Project	IEEE 802.16 Broadband Wireless Access Working Group < http://ieee802.org/16 >	
Title	Enhancement for rate 2, 4-transmit antenna STC	
Date Submitted	2005-1-20	
Source(s)	<p>Jianzhong (Charlie) Zhang, Kiran Kuchi, Anthony Reid</p> <p>Nokia Research Center 6000 Connection Drive Irving, TX 75039</p> <p>Chan-Byoung Chae, Wonil Roh, Sung-Ryul Yun, Kyunbyoung Ko, JeongTae Oh, Hongsil Jeong, Seungjoo Maeng, Panyuh Joo, Jaeho Jeon, Jaeyeol Kim, Soonyoung Yoon</p> <p>Samsung Electronics Co., Ltd.</p> <p>Young-Ho Jung, Seung Hoon Nam, Jaehak Chung, Yungsoo Kim</p> <p>Samsung Advanced Institute of Technology</p>	<p>Voice: 972-374-0958, 972-374-1862 Fax: 972-894-5937 charlie.zhang@nokia.com, kiran.kuchi@nokia.com</p> <p>cb.chae@samsung.com</p>
Re:	IEEE 802.16e D5 Draft	
Abstract	Proposes an enhancement to rate 2, 4-transmit antenna space time code	
Purpose	To incorporate the changes proposed here into the 802.16e D5 Draft.

Enhancement for rate 2, 4 transmit antenna STC

Figure1: FER performance of circulated matrix B

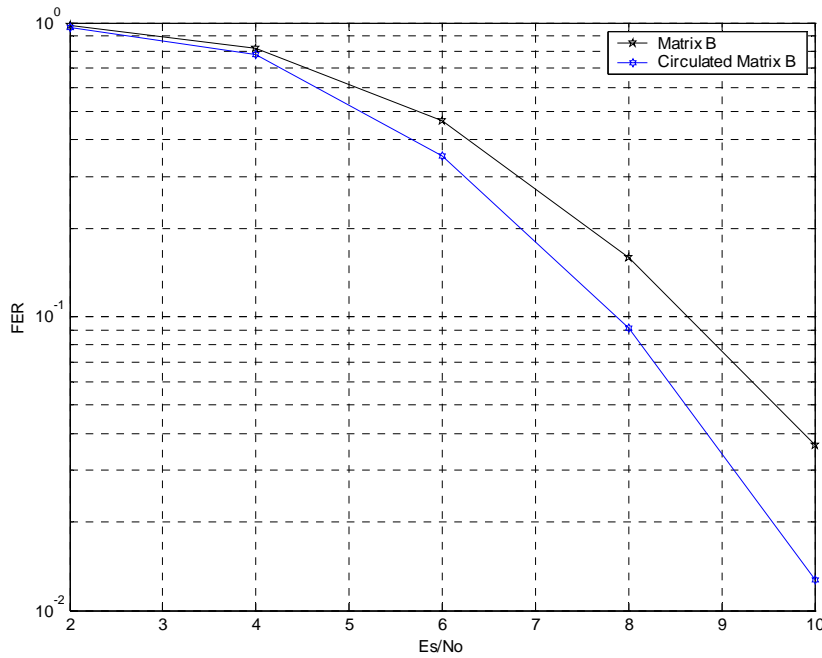
In Figure 1, we compared the FER performance of the circulated code to Matrix A for 4 Tx and 2 Rx case in for Ped A channel, rate 1/2 convolutional code, QPSK modulation using LMMSE receiver. We notice an increase in coding gain up to 1.0 dB. Similar gains are observed for other modulation and coding modes.
